# Victoria Riverside
# Changes to Planning Approved Design

# Changes to Approved Planning Design
Document History

**Project name:** Victoria Riverside (Dantzic Street)
**Project number:** 18059
**Document reference:** VRS-HBA-00-XX-RP-A-00-0005
**Reason for issue:** Planning Changes Tracker
**Date** 20.11.2020
**Revision** Rev 7 - 10.06.2024

**Drawing**
Proposed Level 02 Floor Plan

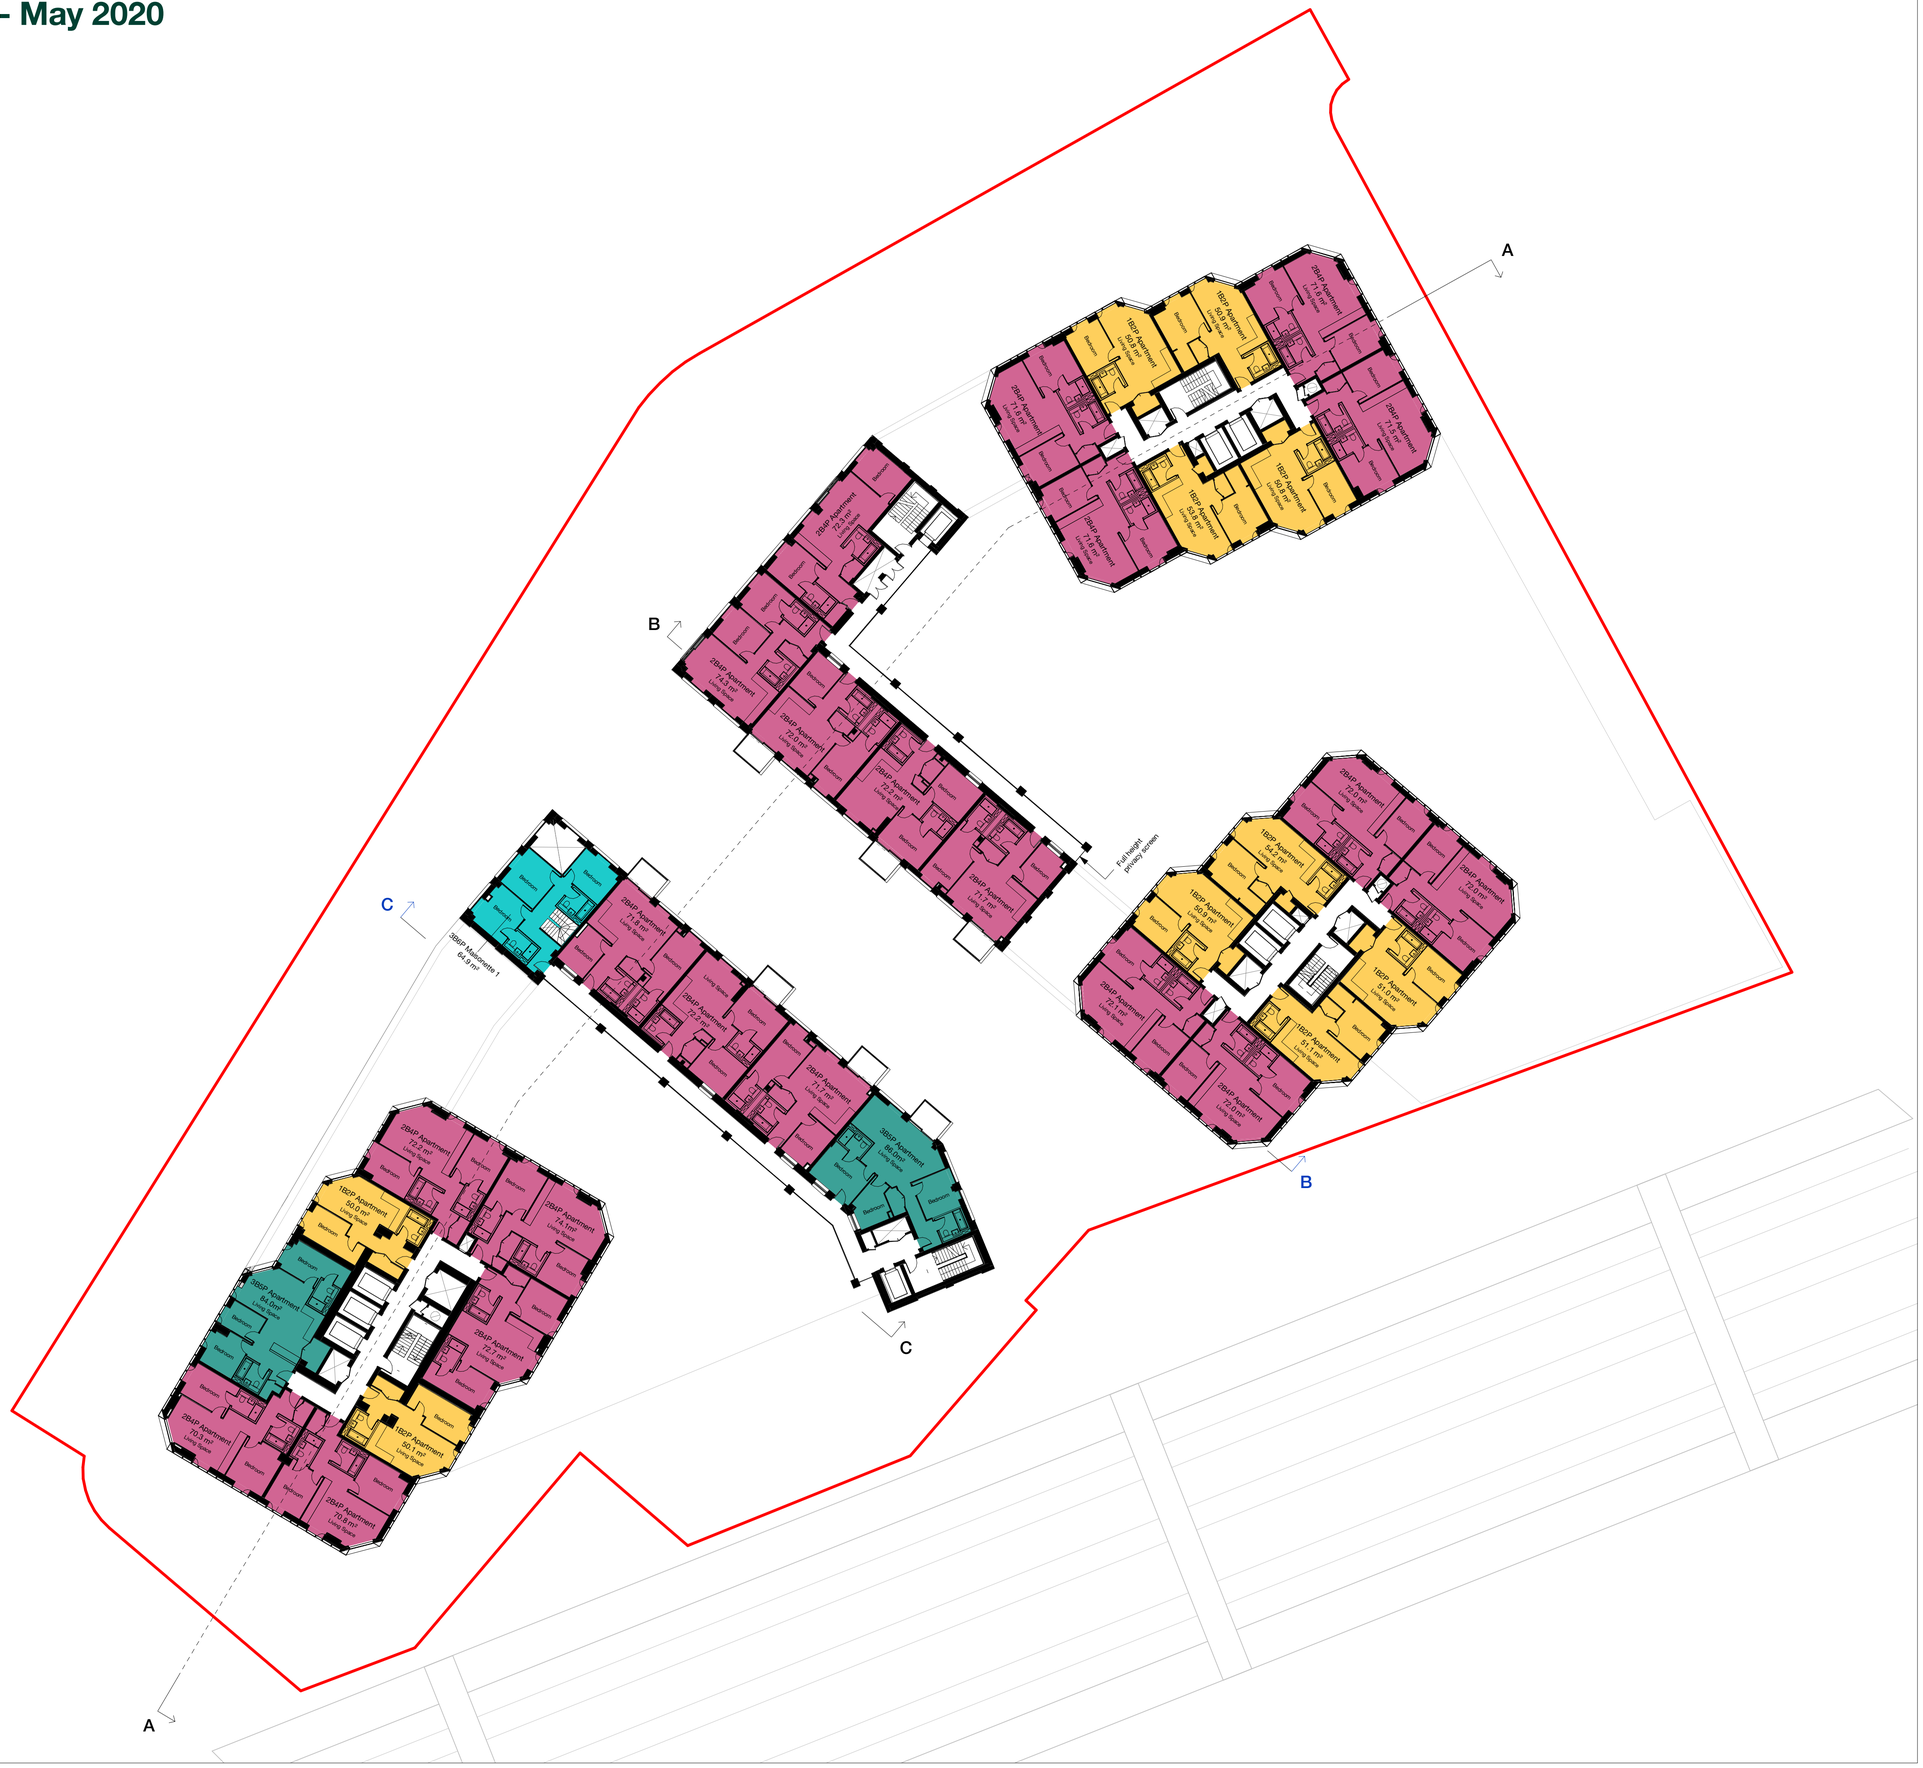
| Change Number | Change Details | Description | Technical Requirement | Design Led Change | Planning Information Impacted | Date Added to Schedule |
|---|---|---|---|---|---|---|
| 11 | Additional door added at threshold between core and external walkway to Tower A podium block on Levels 01 and 02 | In the planning approved design, the access to the external walkway was through an opening in the façade. Through design development during the tender period, we looked to add a door in the opening to simplify the line of the thermal envelope and improve the thermal performance in these areas. We have proposed a full height glazed door to minimise the visual impact of this change. | Yes | Yes | VRS-HBA-ZZ-02-DR-A-080102<br>VRS-HBA-ZZ-03-DR-A-080103<br>VRS-HBA-ZZ-XX-DR-A-080302 | 13.11.20 |
